## **ADDENDUM NO. 1 - OUTLINE AND SUMMARY INFORMATION**

Project Name: Julia Martin Stairs PPA No.: 22-0656  
Location: Montana State University - Bozeman Date: 12/20/2023  
Owner: State of Montana, MSU - Bozeman  
Plew Building 6<sup>th</sup> and Grant, PO Box 172760  
Bozeman, Montana 59717-2760

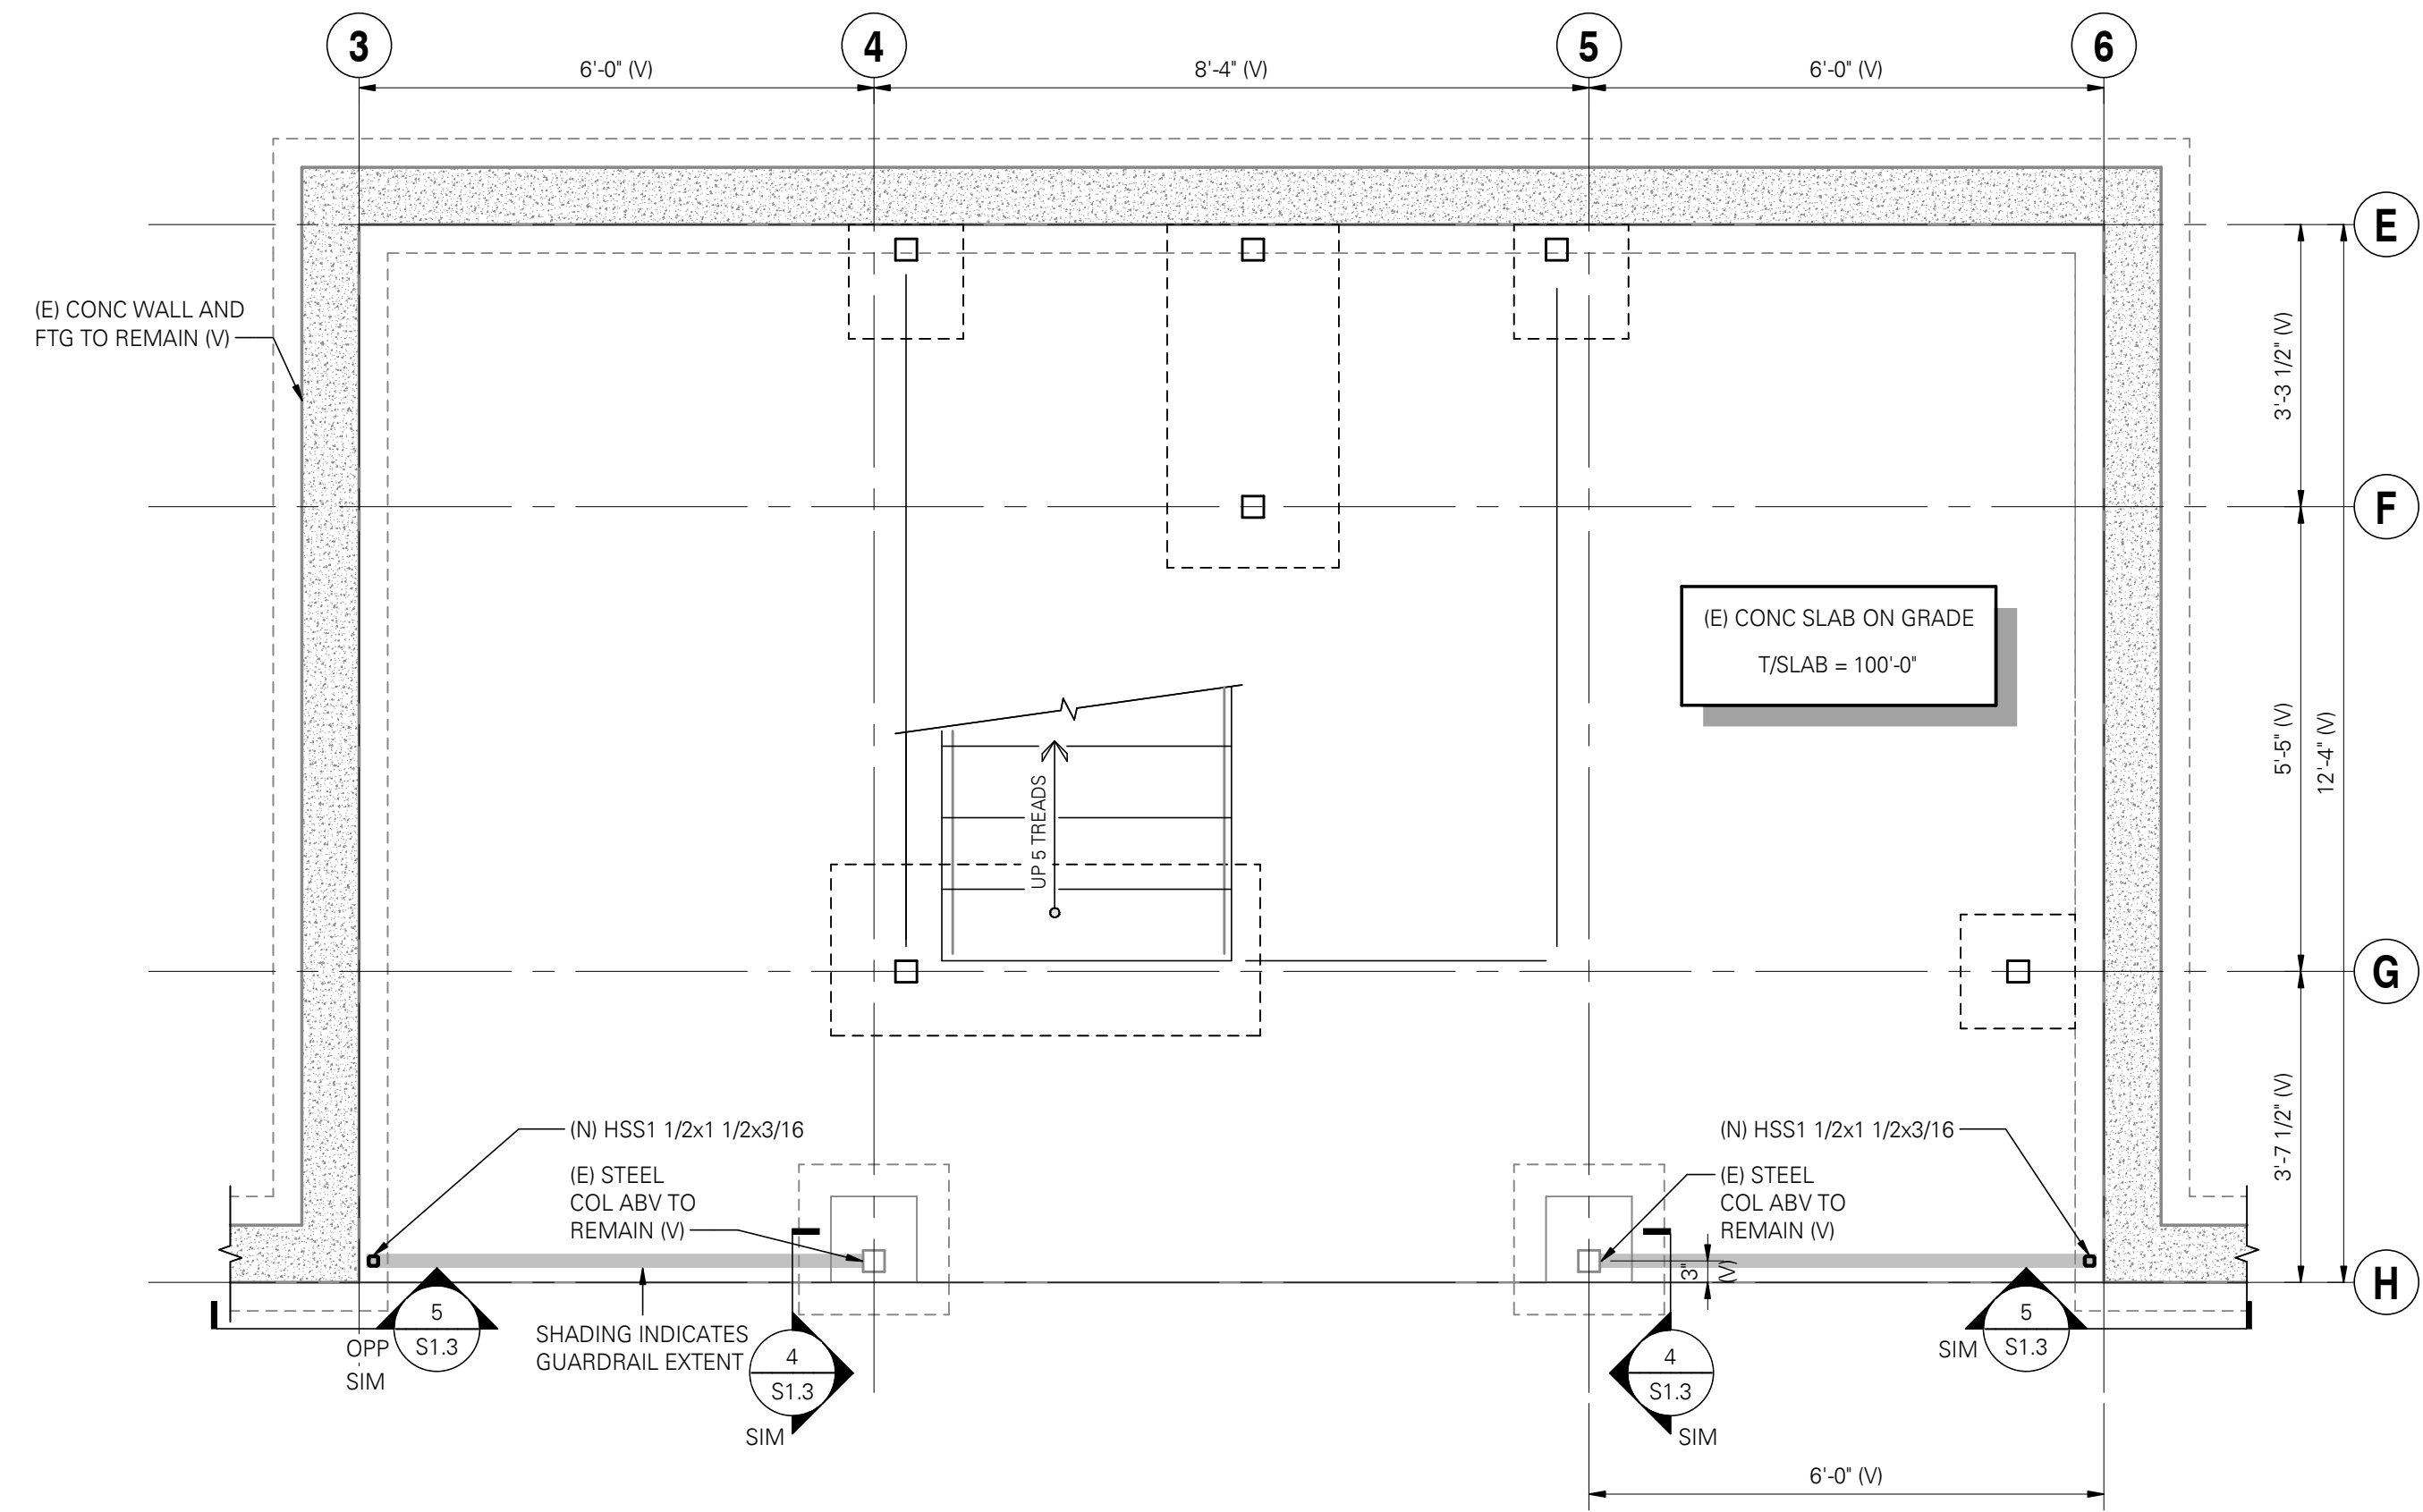
17. Time of Completion
  - 17.1. Bidder agrees to commence work immediately upon receipt of the Notice to Proceed and to substantially complete the project **by August 9<sup>th</sup> 2<sup>nd</sup>, 2024** or **within 90-(82) consecutive days**.
